Japan would propose to amend the Annex 2 “Examples of Arrangement of Approval Marks” of R.XXX, as shown in the attached sheets.

Annex 2

Figure 9: in respect to the class C ~~(basic)~~ passing beam the class W passing beam both with bending modes and a driving beam, and designed for right-hand traffic only.

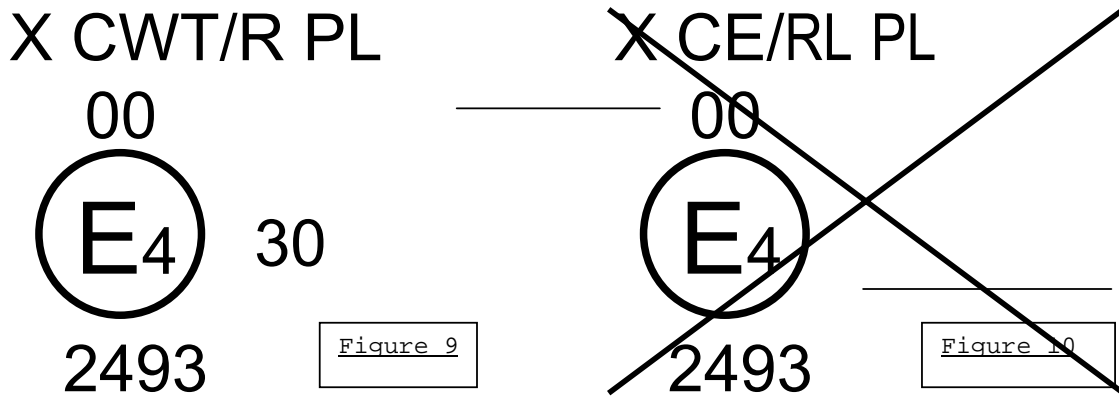
~~Figure 10: in respect to the class C (basic) passing beam with class E passing beam, designed for right hand traffic only, and a daytime running light.~~

The passing beam and its modes shall not operate simultaneously with the driving beam in Figure 9, ~~and the daytime running light in Figure 10~~, and/or another reciprocally incorporated headlamp.

Figure 11

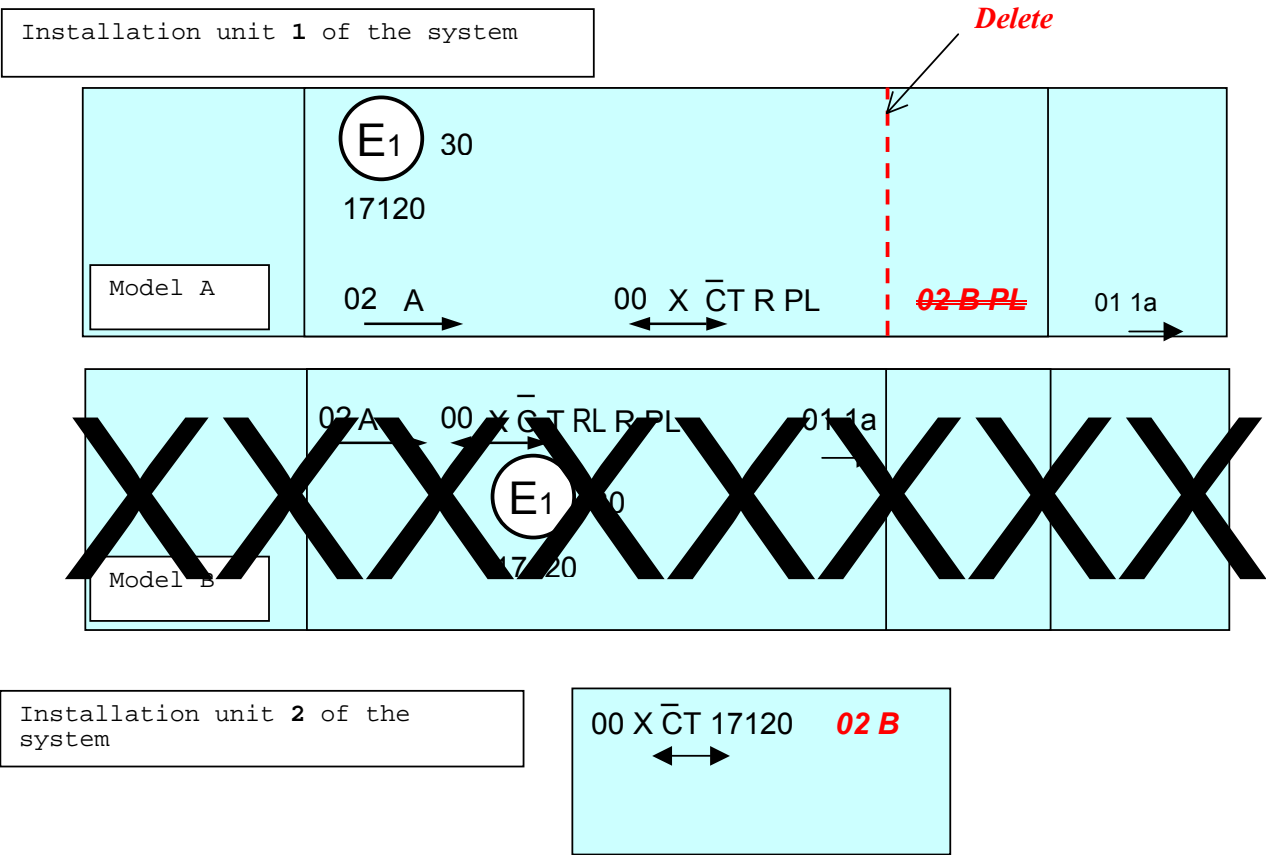
A front fog lamp is allowed to activate as part of some lighting function provided by an AFS, according to Paragraph 6.3.6.1 of R.48. For the purpose of clarification, the approval mark in such a case should be also shown, as an example. In the amended Figure 11 in Annex 2, an approval mark of installation unit 2, which has 2 functions of front fog lamp and passing beam with bending mode, is shown.

Simplified marking for grouped, combined or reciprocally incorporated lamps, when approved according to other than this Regulation (Figure 11):

These two examples correspond to two installation units on one side of a system, bearing an approval mark comprising:

Installation unit 2

A front fog lamp approved in accordance with the 02 series of amendments to Regulation No. 19 in Model A, or

~~One or more lighting unit(s), with~~ a class C (basic) passing beam with bending mode, designed for right- and left-hand traffic, provided to work with one or more other installation unit(s) on that side of the system, as indicated by the score above "C".
